IDAP REPORT

Property:	25 Hunter Street STRATHFIELD DA 2020/132
Proposal:	Demotion of all existing structures, tree removal, proposed dwelling house with a basement level and an in-ground swimming pool.
Applicant:	NEMCO DESIGN PTY LTD
Owner:	E Abdallah and R Taouk
Date of lodgement:	5 August 2020
Notification period:	19 August 2020 to 02 September 2020
Submissions received:	One
Assessment officer:	P Santos
Estimated cost of works:	\$1,491,434.00
Zoning:	R2 - Low Density Residential - SLEP 2012
Heritage:	Subject site does not contain a Heritage Item or is within a Heritage Conservation Area. A Heritage Item – (I126) “Fairholm” Victorian House, adjoins the subject site.
RECOMMENDATION OF OFFICER:	REFUSAL

Figure 6. Extract of the basement floor plan (source: Nemco Design, dated 22/09/2020)

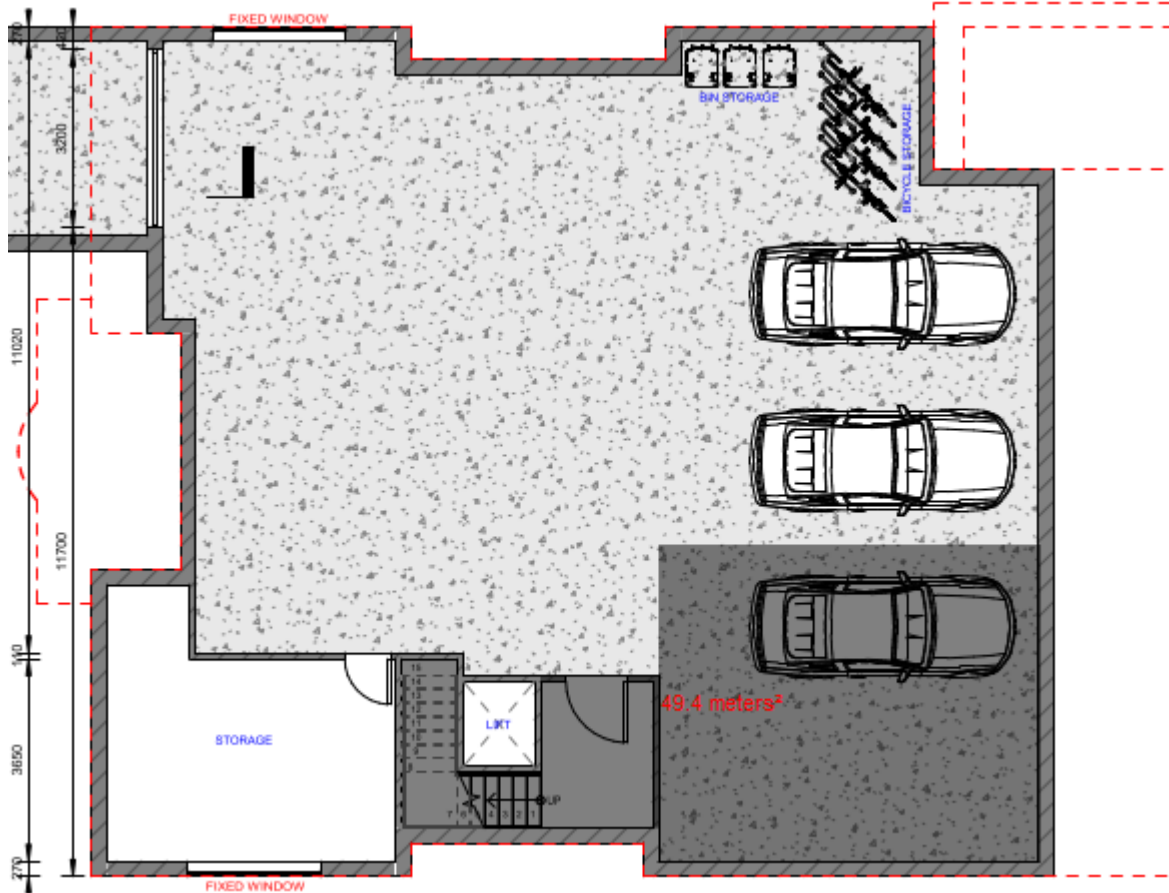
The gross floor area calculation in the basement does not include the following:

- 40m² double parking space, that is required in the SCDP 2005;
- Lift void;
- 21m² of storage space; and
- Vehicular manoeuvring area.

The basement as shown in Figure 6 includes a storage room, three parking spaces and a lift void, a lobby and a set of stairs. As per the definition of GFA in the SLEP 2012, the manoeuvring area of the two parking spaces, the two parking spaces and the lift void have been excluded in the FSR calculation. The third parking spot, as it is beyond what is required by Council for parking spaces, and the lobby and stairs, as it provide access to not just the parking spaces but to the storage space as well, are included in the FSR. As such, the gross floor area in all three storeys exceed the maximum permitted on the site, and is unsupportable.

Figure 7. Extract of the ground floor plan (source: Nemco Design, dated 22/09/2020)

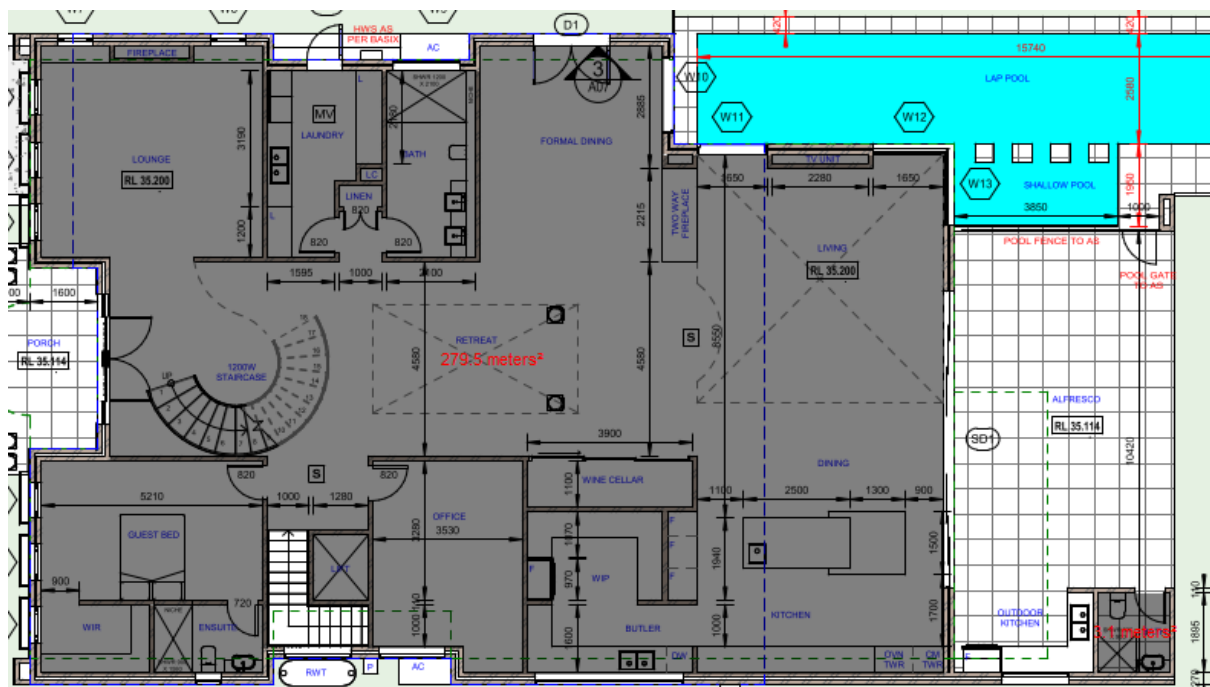
As shown in Figures 7 and 8 above, the ground floor and the first floor have a combined floor area of 478m². The maximum permitted GFA on the site is 481.9m². This already puts just the ground floor and first floor on the edge of the permitted GFA.

Figure 8. Extract of the first floor plan (source: Nemco Design, dated 22/09/2020)

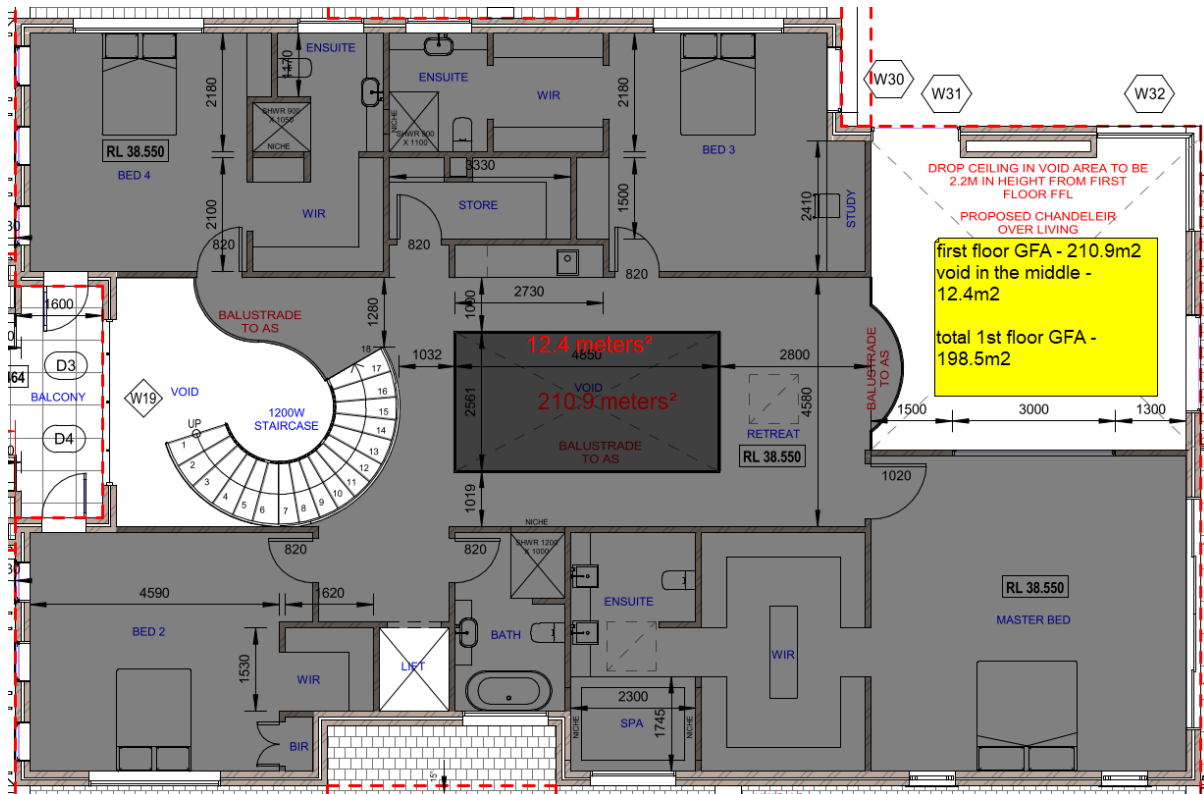
As shown in Figures 6 to 8 below, Council's calculation of the FSR is broken down per level. The areas shaded in grey are the areas included in the FSR calculation, with the exclusion of the void in the middle of the first floor that is to be excluded in the first floor gross floor area.

Figure 9. Extract of the proposed first floor (source: Nemco Design, dated 22/09/2020).

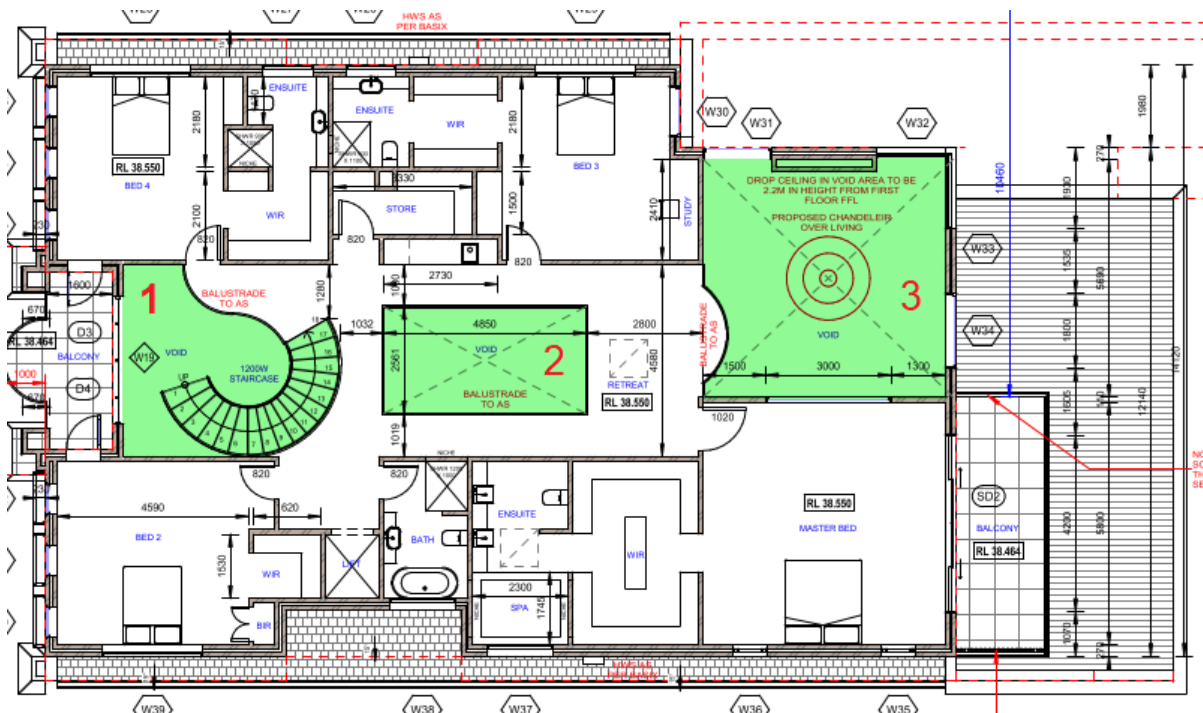
The proposed development is for a dwelling house that involves three voids over the ground floor level. See Figure 9 below. The voids, essentially, will make the ceiling height from the ground floor level be over by 3.2m from the required height of 3m, totalling a height of 6.2m.

Void 1 in the image below is to an entry and is an acceptable non-compliance. Void 3 over the ground floor living room will have a reduced ceiling height of 5.55m and is considered acceptable as it will have a ceiling height of no more than 2.2m from the first floor FFL. Void 2 will have the highest ceiling height of 6.2m. A 106% variation non-compliance.

Despite the above, Void 2 is supportable as it acts as a design feature of the dwelling house that would have no real impact on the scale of the building.

Figure 12. Extract of the marked-up front fence elevation (source: Nemco Design, dated 22/09/2020)

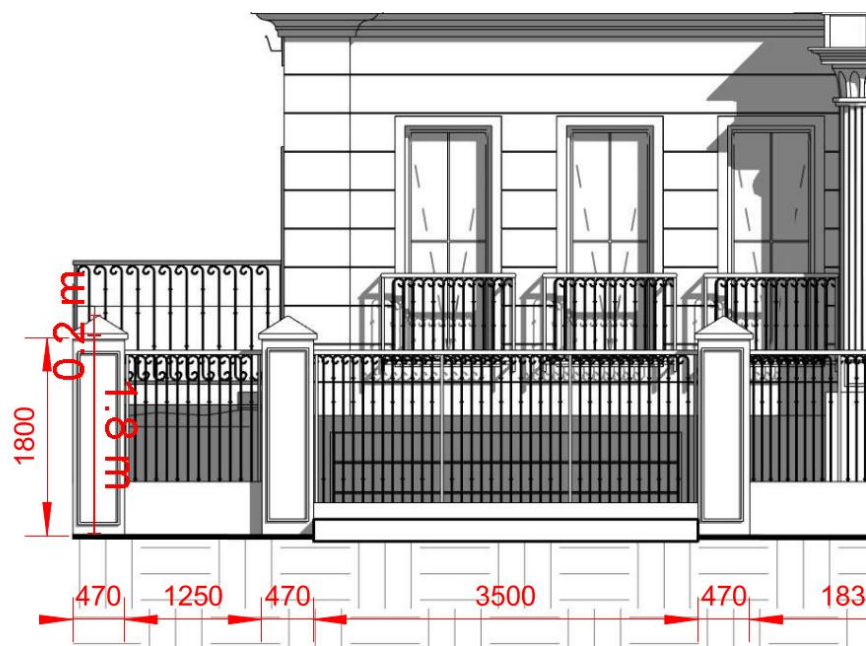
The proposed development involves an open-form front fence that has a height of 2m. Figure 11 below shows that the 1.8m maximum fence height that the SCDCP 2005 requires is not measured to the fence's highest point. Figure 12 is a marked-up elevation that demonstrates additional 0.2m part of the front fence that had not been included in the measurement.
